CODY ROAD FOOD MART SUBDIVISION

APPLICATION NUMBER 3 DATE February 15, 2007

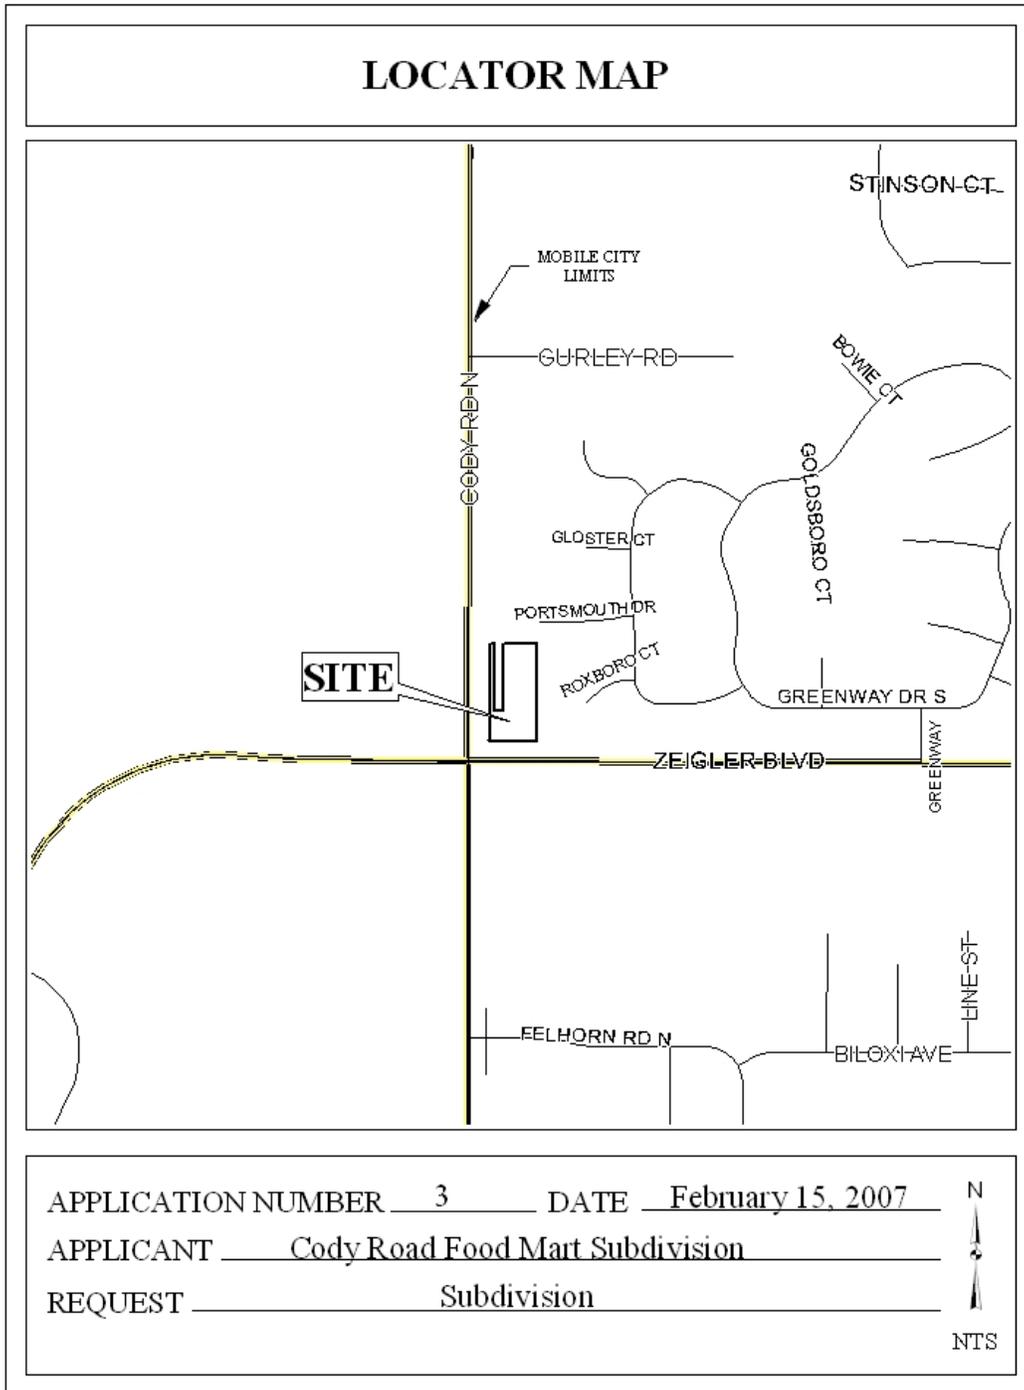
The site fronts onto Cody Road and Zeigler Boulevard, both proposed major streets. The plat appears to indicate that land has been set aside for a service road along Cody Road, as required by the conditions associated with the rezoning of the site in 1978. It appears that there are discrepancies, however, regarding the required land dedication related to the rezoning and the plat, when compared to City of Mobile and Tax Assessor maps. It is recommended, therefore, that the application be heldover until the March 15th meeting in order to allow staff and the applicant time to resolve the identified issues.

Access management is a concern because of the site's frontage on two major streets. The proposed lot should be limited to two curb-cuts onto Cody Road and two curb-cuts onto Zeigler Boulevard, with the size, design and location to be approved by Traffic Engineering and conform to AASHTO standards.

The 25-foot minimum building setback line from all street frontages, required in Section V.D.9., is not shown on the plat, but would be required on the final plat, if approved.

It should also be pointed out that the parcel (and potential service road area) appears to have been created after 1952, but without going through the subdivision process. The applicant's representative undertook additional title research after being informed of this finding and confirmed that the parcels were created after 1952, specifically in 1967, 1972 and 1977. The applicant's representative also pointed out that the current property owners are not the original owners involved in the original parcel creation. It appears, however, that the deeds provided by the applicant's representative may show overlapping deed boundaries.

Based on the preceding, the application is recommended for Holdover until the March 15, 2007 meeting so that the applicant may undertake the following by February 21: 1) resolution of the discrepancy between City of Mobile and County Tax Assessor parcel data and the information provided on the preliminary plat, which may require modification of the application to include additional parcels, application fees, postage fees and a revised plat; 2) revision of the plat to depict the 25-foot setback line required by Section V.D.9. of the Subdivision Regulations; and 3) revision of the plat to depict the corner radius required by Section V.D.6. of the Subdivision Regulations.
